Docket Item # 15
BAR CASE #2008-0088

BAR Meeting
June 18, 2008

ISSUE: Alterations
APPLICANT: R. J. Lasker
LOCATION: 1321 King St
ZONE: KR/King Street Urban Retail

I. ISSUE:

Figure 2. Proposed demolition and supports.

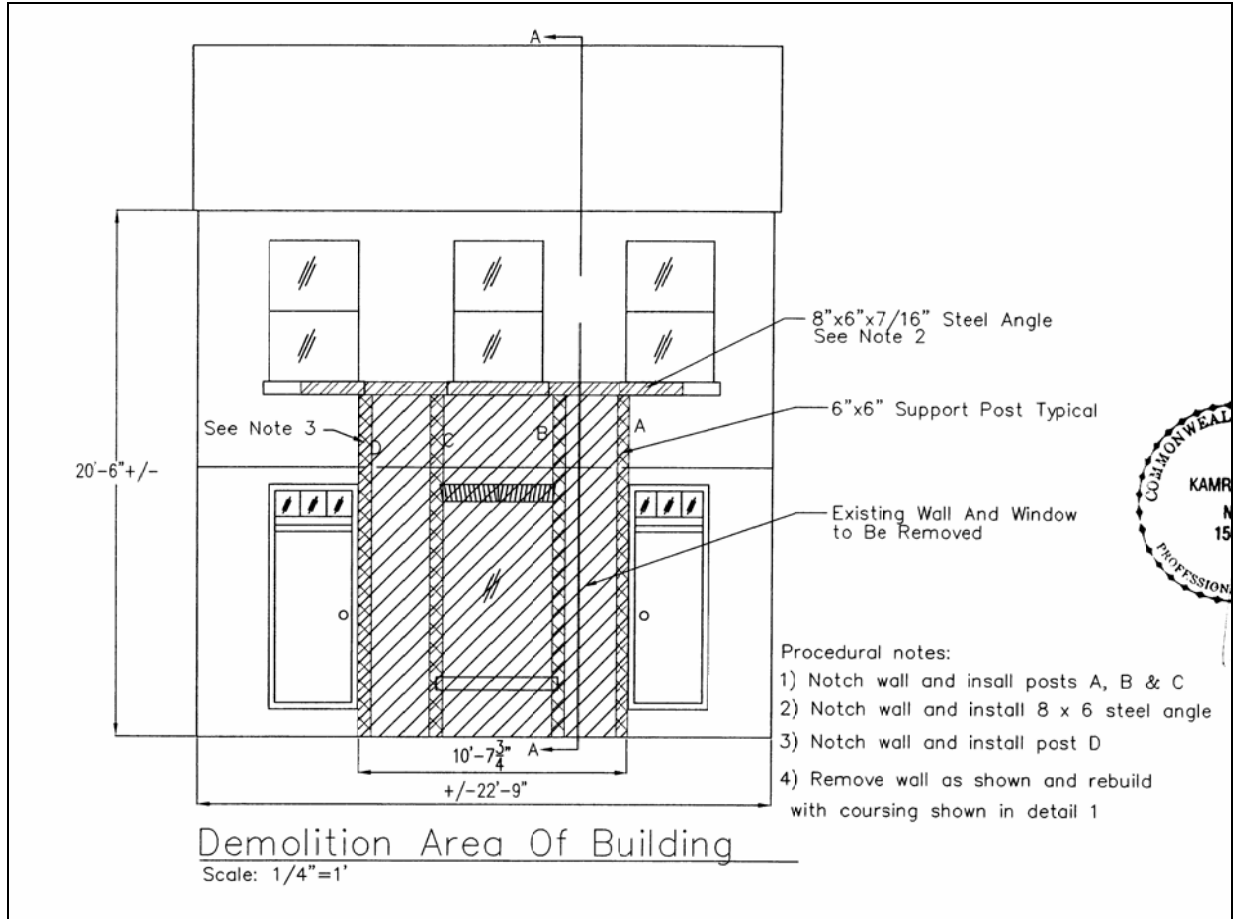
The applicant's structural engineer has identified possible causes as well as the area where selective demolition is necessary. He noted that a portion of the front wall has bowed out and the outside wyth of the brick is separated from the rest of the wall. He observed that the front load bearing wall is only supported by the inner wyths of brick. In addition, the lintel is sagging and needs to be reinforced and rebuilt. To increase the structural strength of the wall, the interior of the repaired portions of the wall will be reinforced with posts and the lintel reinforced with a steel angle.

The applicant does not specify the reuse of the existing brick and window in the submitted materials. Staff recommends that the applicant reuse the existing brick to the greatest extent possible. Where new brick is required, the applicant should work with staff to ensure an appropriate match. In addition, the applicant should ensure that the new mortar matches the existing. The applicant should work with staff to determine an appropriate match.

The *Design Guidelines* state that any proposed demolition, whether in whole or in part, requires the approval of a Permit to Demolish by the Board. However, the removal of less than 25 square feet of an exterior wall is not considered demolition but rather an alteration. The proposed work here is less than 25 square feet and is thus an alteration. However, once work begins, if the applicant will need to expand the area of the proposed demolition, it is recommended that the applicant work with staff to determine what is necessary to make the wall structurally sound and if a Permit to Demolish will be necessary.

1. That the rebuilt portion of the wall match the historic configuration, design, and pattern of the building;
2. That the existing historic bricks be salvaged and re-used to the greatest extent possible in the reconstruction;
3. That the applicant provide staff with an appropriate mortar for final staff approval; and,
4. That the applicant work with staff if additional demolition is necessary.

Figure 3. Proposed details for temporary shoring and rebuilding.

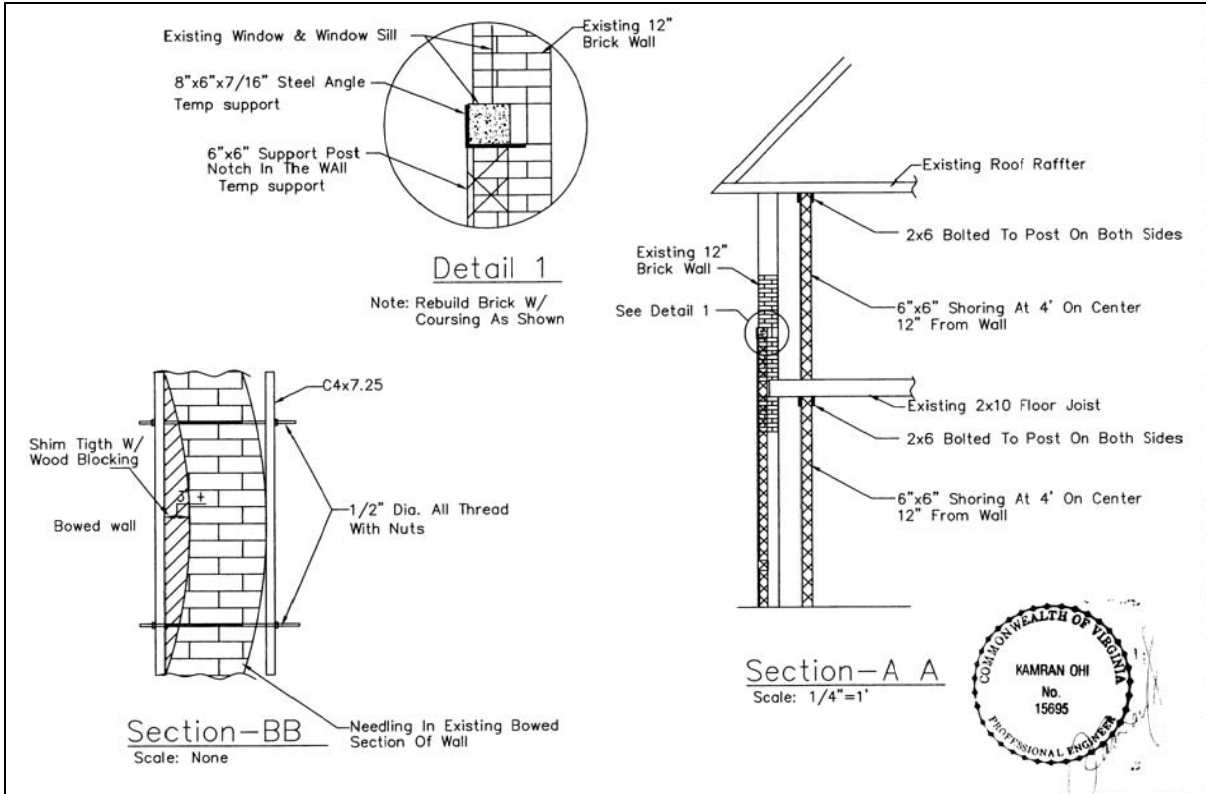
- C- 5 Sheeting and shoring shall not extend beyond the property line; except when the developer has obtained a written release from adjacent property owners which has been recorded in the land records; or through an approved encroachment process.
